**Economic and Social Council**Distr.: General
8 April 2022

Economic Commission for Europe**Inland Transport Committee****World Forum for Harmonization of Vehicle Regulations****187th session**

1958 Agreement:**Pending proposals for amendments to existing UN Regulations submitted by GRE and GRSG****Proposal for Supplement 3 to the 07 series of amendments to UN Regulation No. 48 (Installation of lighting and light-signalling devices)****Submitted by the Working Party on Lighting and Light-Signalling***

Annex 1, item 9.22., amend to read:

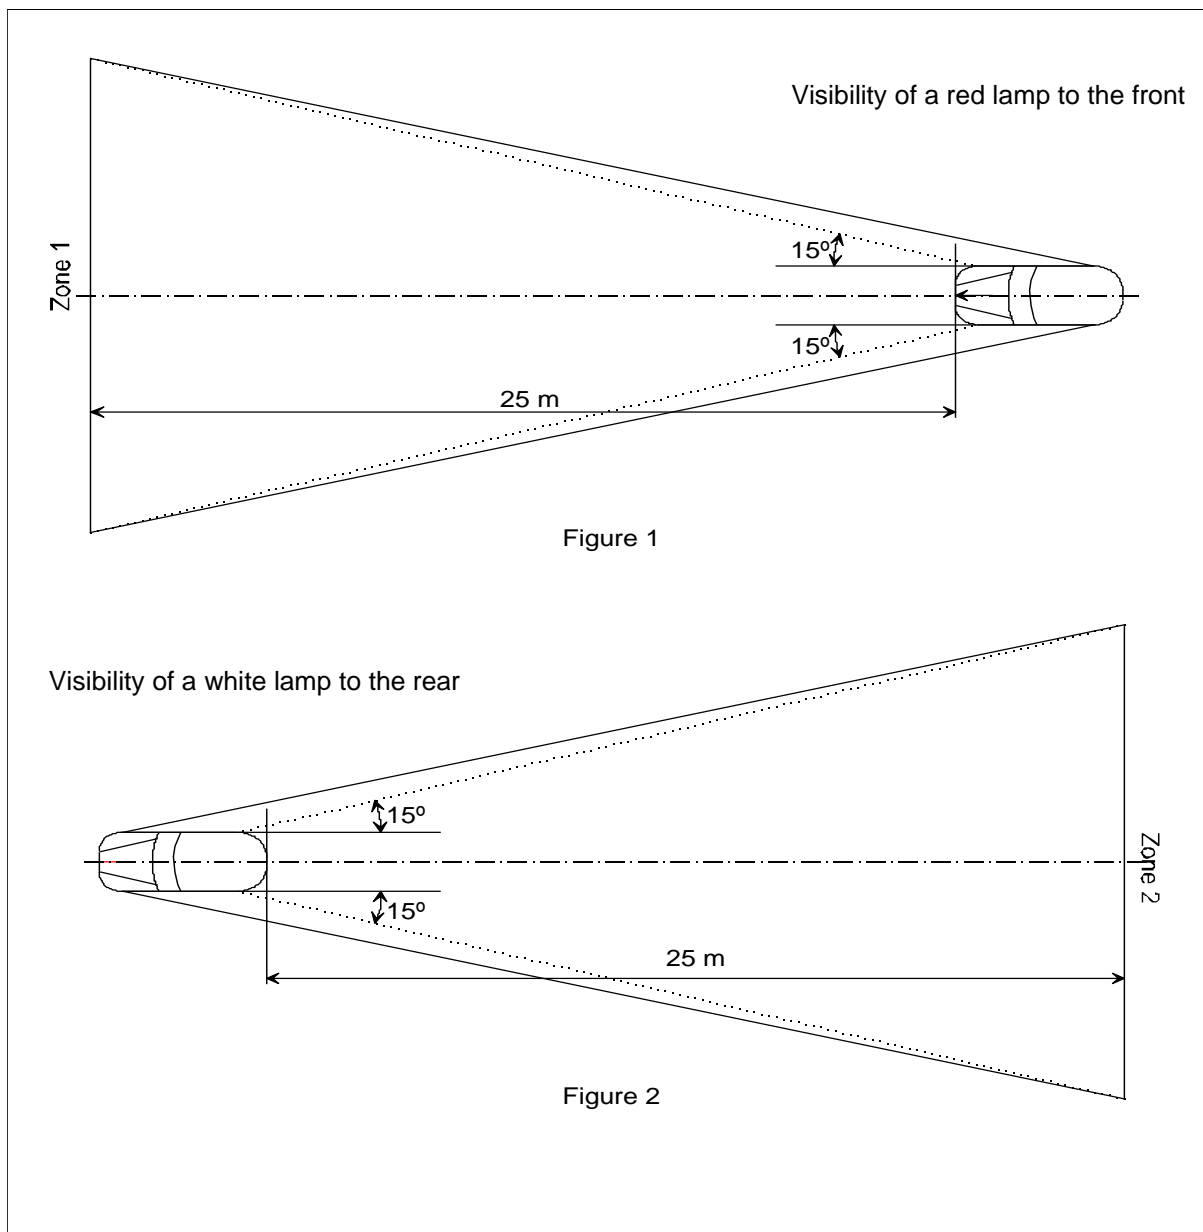
"9.22.	Adaptive front lighting system (AFS):	yes/no ²
9.22.1.	Main-beam ADB	yes/no ²
9.22.1.1.	Main-beam ADB + Driver Assistance Projection	yes/no ² "

“Annex 4

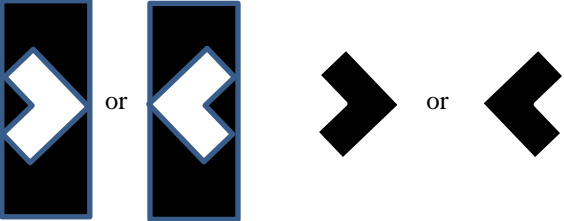
Visibility of a red lamp to the front and visibility of a white lamp to the rear

In their respective planes, the zones 1 and 2 explored by the eye of the observer are bounded:

- In height, by two horizontal planes 1 m and 2.2 m respectively above the ground;
- In width, by two vertical planes which, forming to the front and to the rear respectively an angle of 15° outwards from the vehicle's median longitudinal plane, pass through the point or points of contact of vertical planes parallel to the vehicle's median longitudinal plane delimiting the vehicle's overall width; if there are several points of contact, the foremost shall correspond to the forward plane and the rearmost to the rearward plane.”
